INFO-TECH CITROËN Sport C2 R2 MAX N° 07/08.

Sujet : Clutch disk, pads.

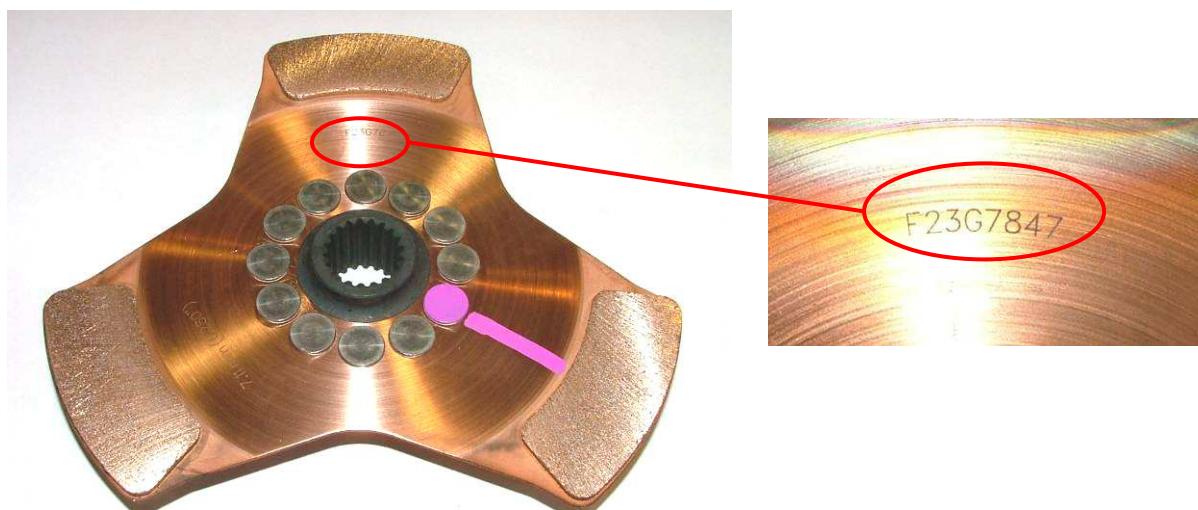
A defect has been discovered on C2R2 / MAX clutch disks (part number 1C1143317A). Please pay attention on informations below :

If you have a **brand new disk, never assembly** on your engine, and you can see **F23G7847** number written on it (as shown on pictures below), please send it back to us. A brand new one, from a different serial will be sent to you as soon as possible.
